From: [REDACTED]
Sent: 23/01/2023 4:34:55 PM
To: Council Northernbeaches Mailbox
Cc: Lynn Chalmers
Subject: TRIMMED: DA 2022 2246 206 HUDSON PARADE CLAREVILLE NSW
2107 WRITTEN SUBMISSION: LETTER OF OBJECTION
Attachments: 206 HUDSON WS.pdf;

SUBMISSION

ROBERT & LYN CHALMERS, 208 HUDSON PARADE, CLAREVILLE NSW 2107

RE: DA 2022 2246
206 HUDSON PARADE CLAREVILLE NSW 2107
WRITTEN SUBMISSION: LETTER OF OBJECTION
SUBMISSION: TULLOCH

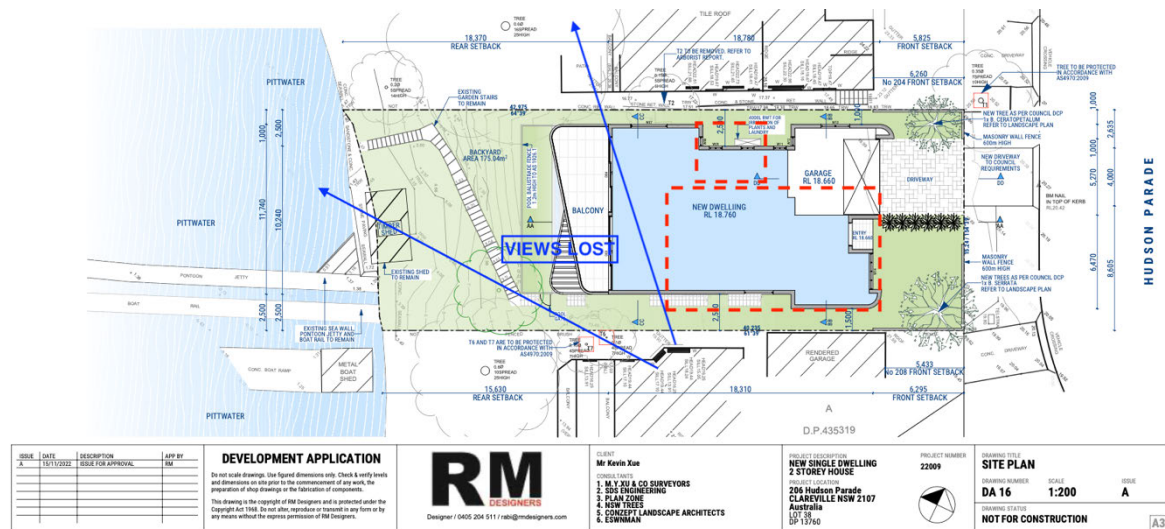
An arc of view is available when standing at a central location in the highly used zones including entertainment decks, highly used rooms, and private open spaces on my clients' property.

The composition of the arc is constrained over the subject site boundaries, by built forms and landscape. The central part of the composition includes the subject site. Views include scenic and valued features as defined in Tenacity. The proposed development will take away views for its own benefit. The view is from my clients' highly used rooms towards the view. The extent of view loss exceeds moderate and the features lost are considered to be valued as identified in Step 1 of Tenacity.

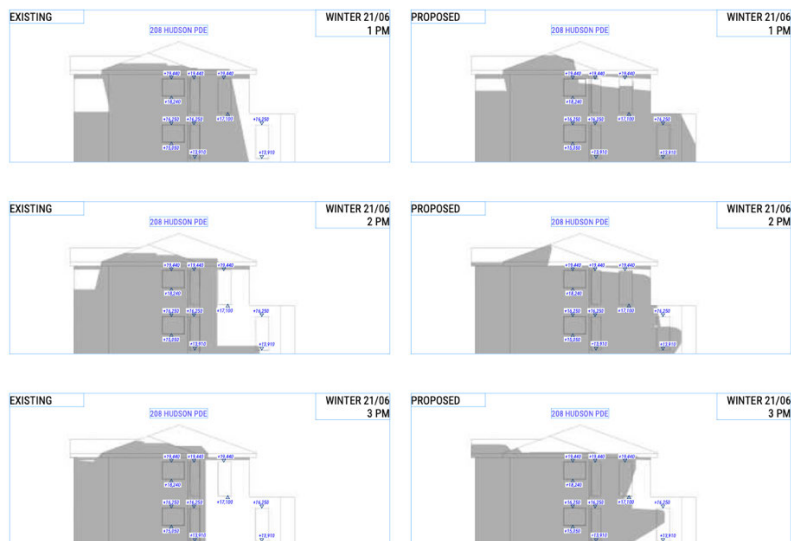
This can only be fully assessed once elevational solar drawings at hourly intervals are submitted. What has been submitted gives the very clear indication that the outcome is not in accordance with controls

- Overshadowing by fences, roof overhangs and changes in level should be taken into consideration. Overshadowing by vegetation should be ignored, except that vegetation may be taken into account in a qualitative way, in particular dense hedges that appear like a solid fence.*

There is no major overshadowing as a result of vegetation
